**RE - YOUR REF OPW201101805, 84-160 CHRISTENSEN ROAD SOUTH STAPYLTON,
INFORMATION REQUEST FOR THE LANDSCAPE PLAN ASSESSMENT**

INFORMATION REQUEST

Landscape Assessment

PROJECT:
WAREHOUSE AND OFFICE

DRAWING TITLE(S):
PLANTING PLAN

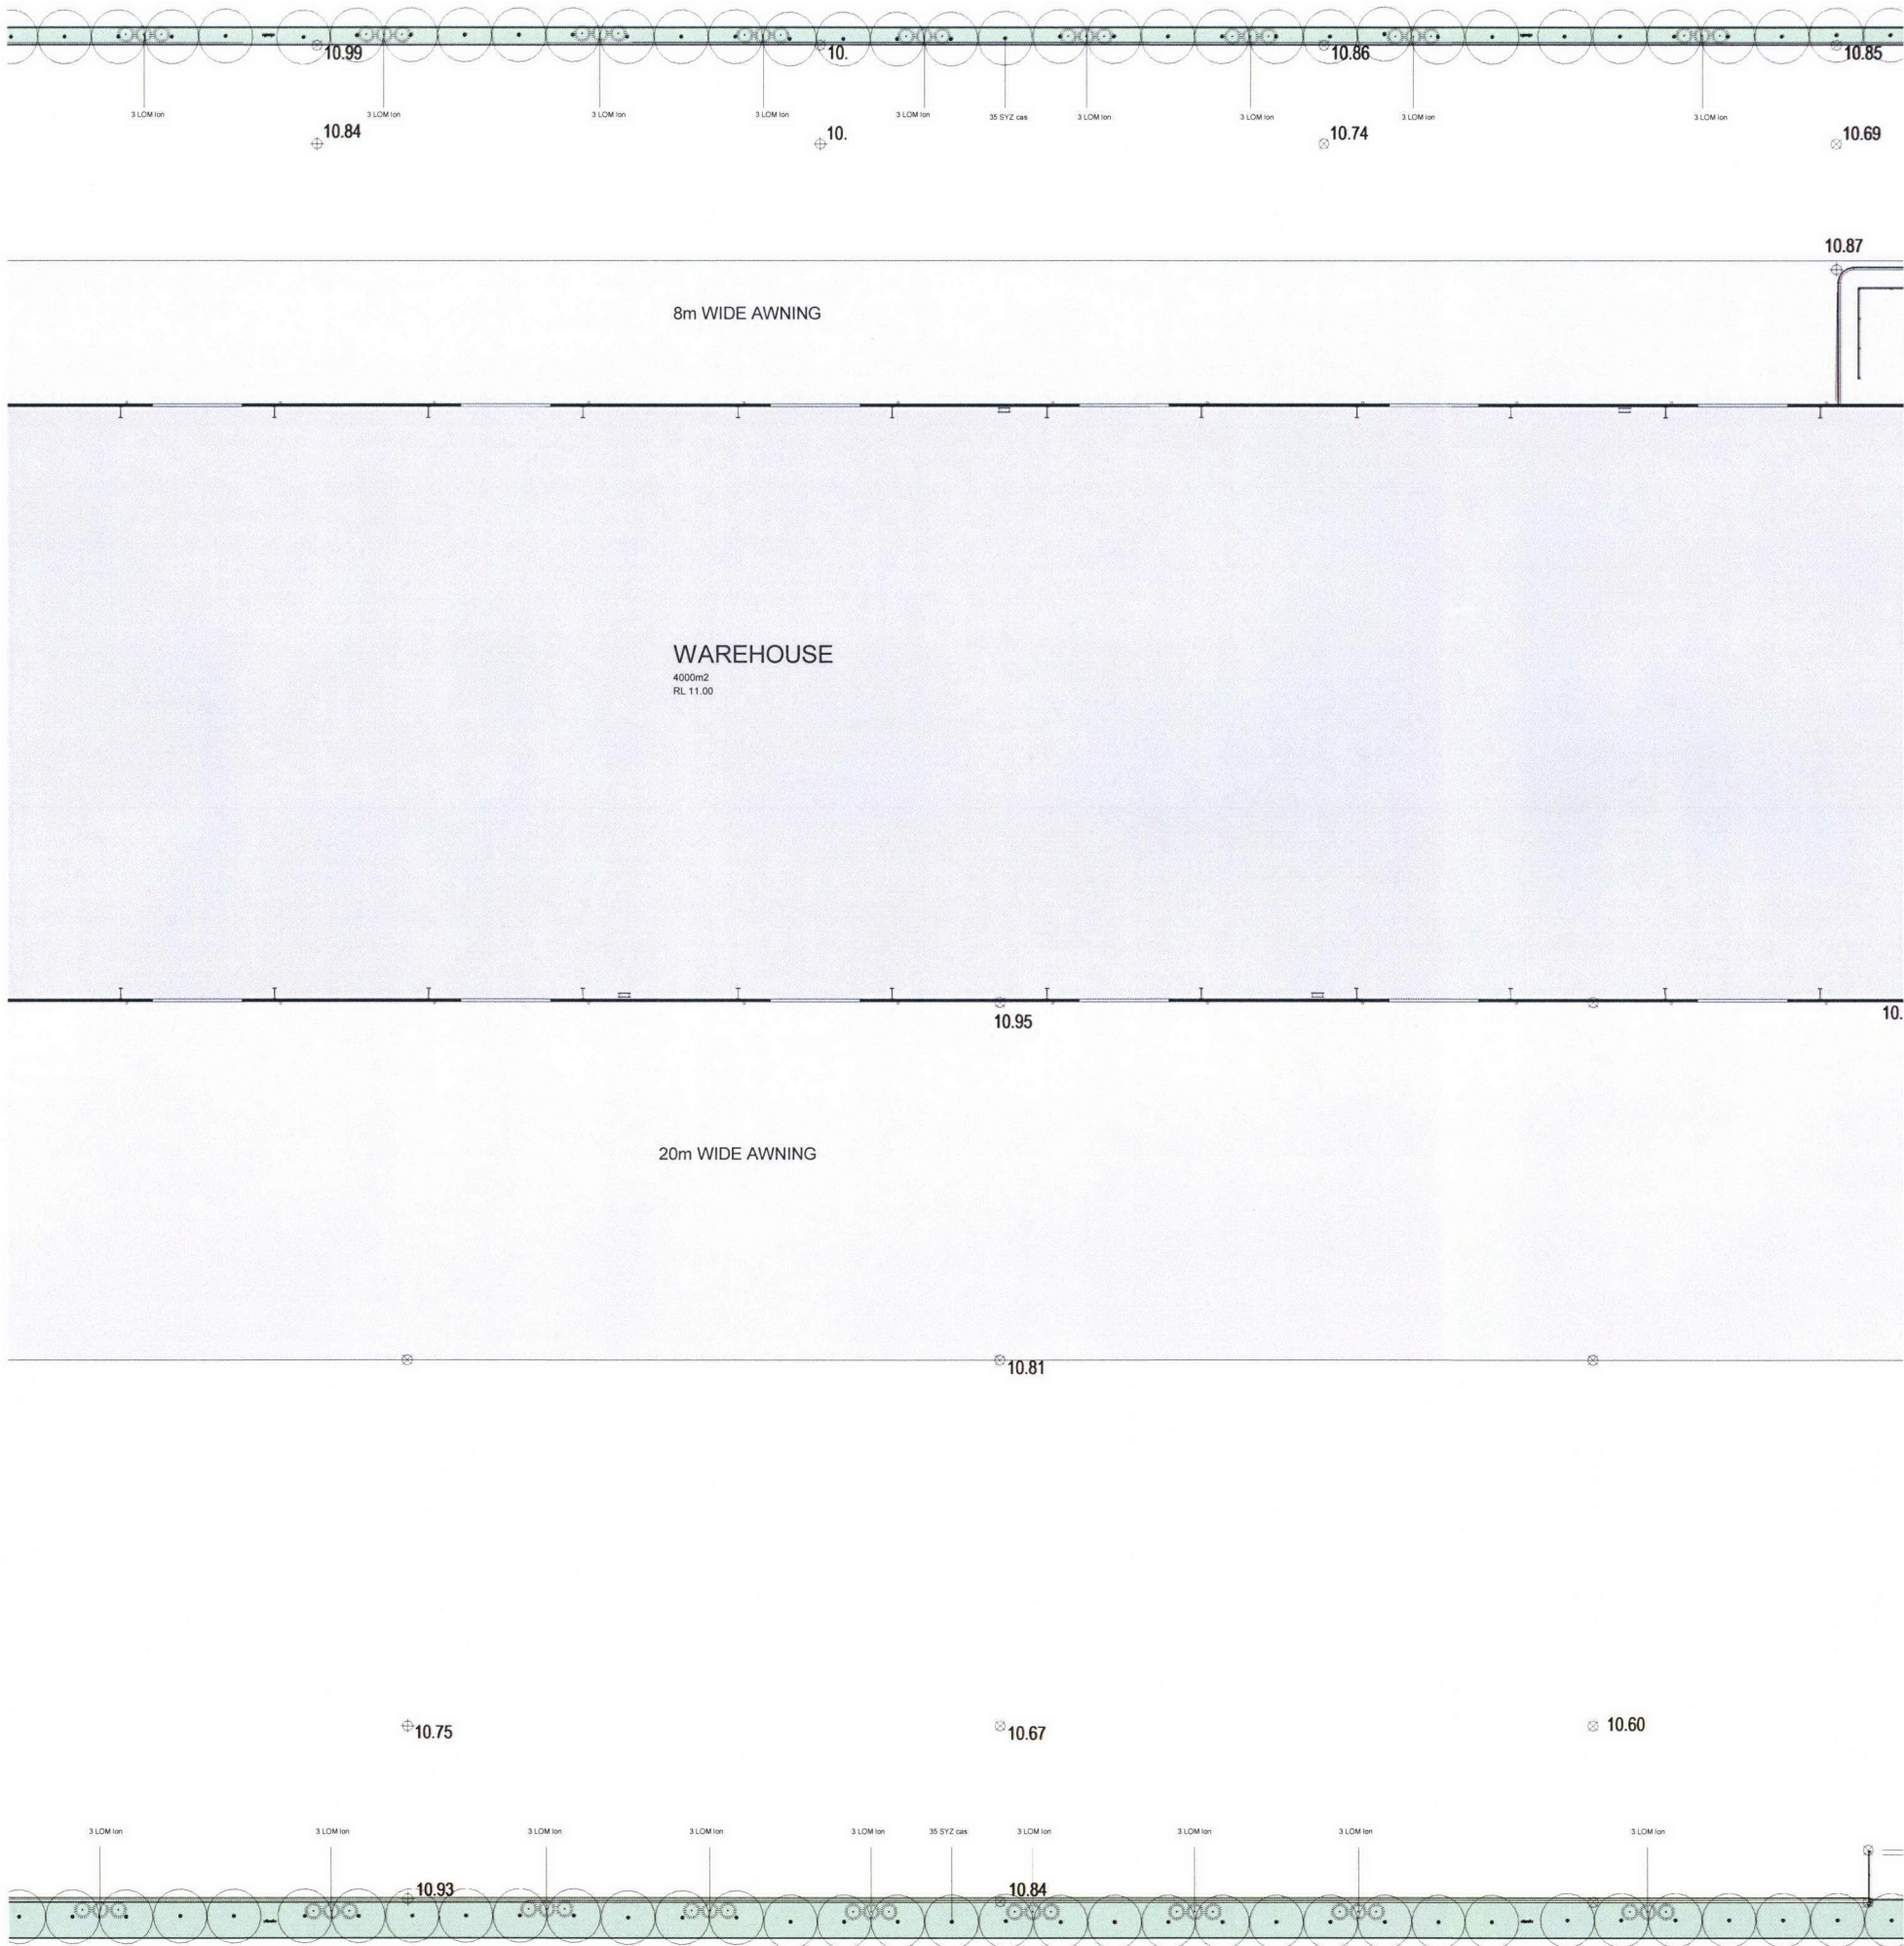
- 3 The applicant is requested to increase the pot size of the proposed *Melalueca quinquenervia* within the frontage setback area to 100L bag size in order to match previous approvals in the Christensen's Rd area.

THE '9 MEL QUI' TO BE PLANTED WITHIN THE FRONTAGE SETBACK AREA ARE TO BE 100L BAG SIZE TREES. THE OTHER '4 MEL QUI' WITHIN THE CARPARK AREA ARE TO BE 45L SIZE WHEN PLANTED.

BIO-RETENTION DETAILS

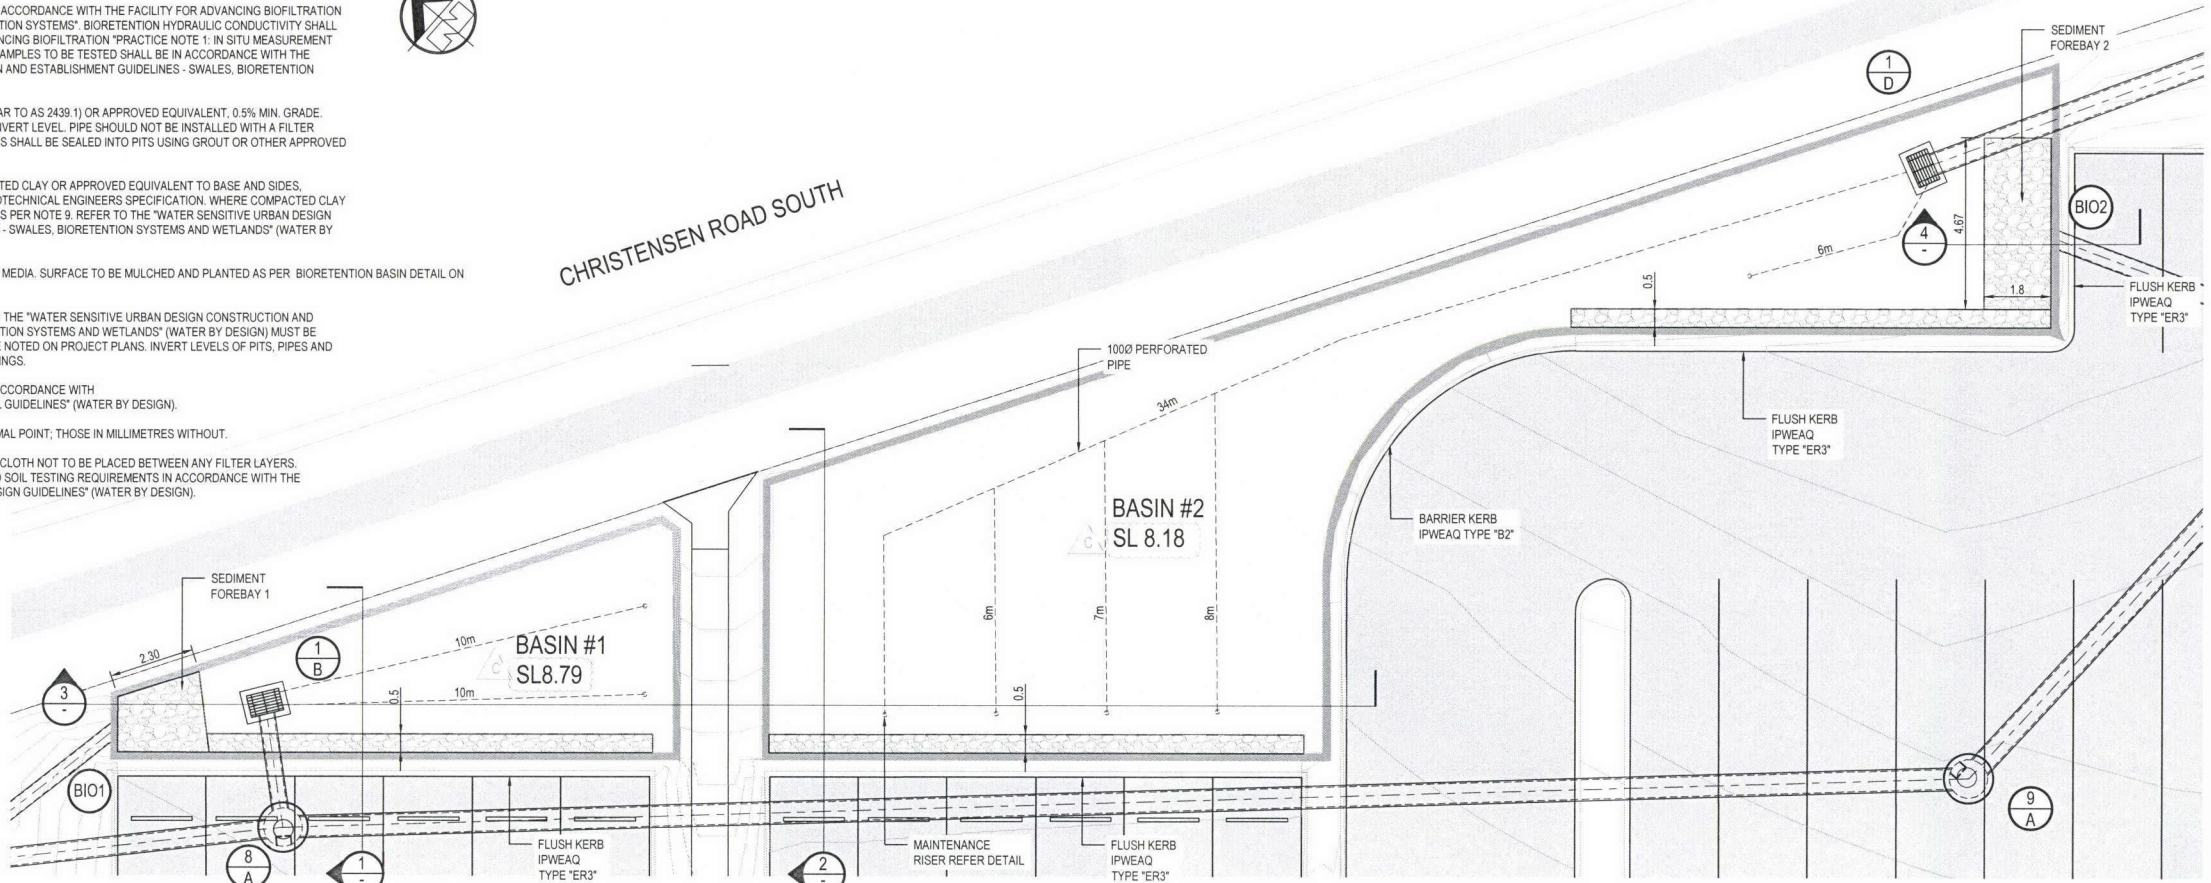
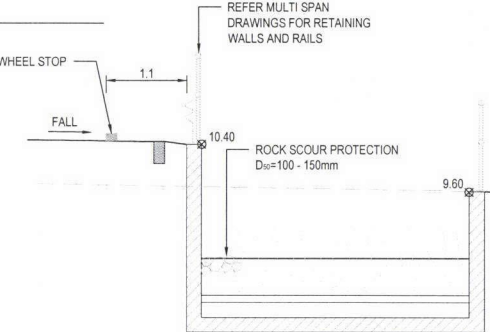
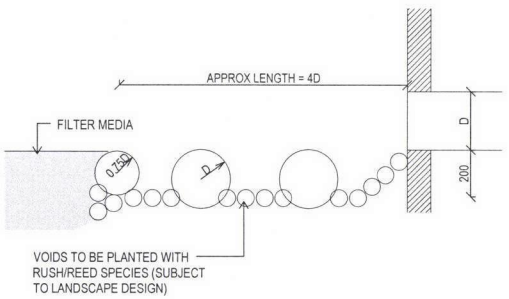
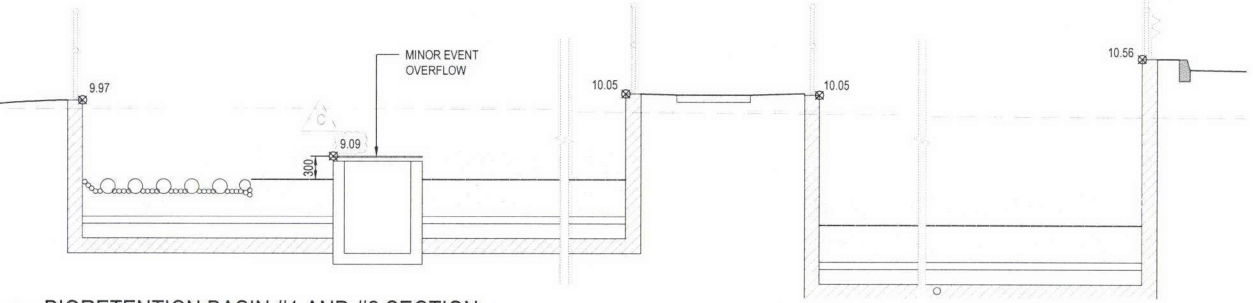
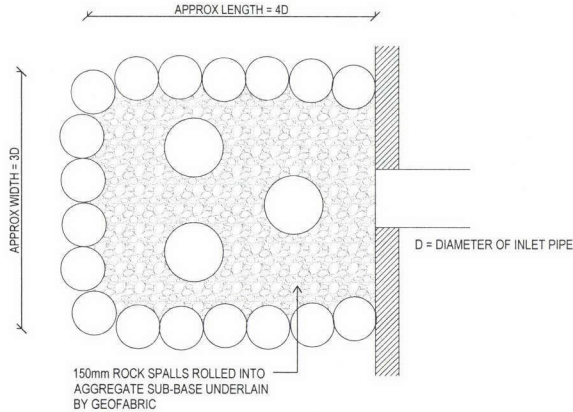
- 5 The applicant is requested to provide further details regarding the bio-retention (in the form of a cross sectional drawing on the landscape plan). Specifically, the applicant is requested to identify the depth of the filter media, and which surface treatment is proposed (*Note – Council will not be supportive of a pebble or river rock mulch due to heat build up and associated plant damage*);

- BASIN FINISHED SURFACE LEVEL IS TOP OF FILTER MEDIA. SURFACE TO BE MULCHED AND PLANTED AS PER BIORETENTION BASIN DETAIL ON DRAWING NO. 11-129C14.
- CONSTRUCTION TOLERANCES AS DOCUMENTED IN THE "WATER SENSITIVE URBAN DESIGN CONSTRUCTION AND ESTABLISHMENT GUIDELINES - SWALES, BIORETENTION SYSTEMS AND WETLANDS" (WATER BY DESIGN) MUST BE ACHIEVED. CONSTRUCTION TOLERANCES MUST BE NOTED ON PROJECT PLANS. INVERT LEVELS OF PITS, PIPES AND BASE LEVELS MUST BE NOTED ON PROJECT DRAWINGS.
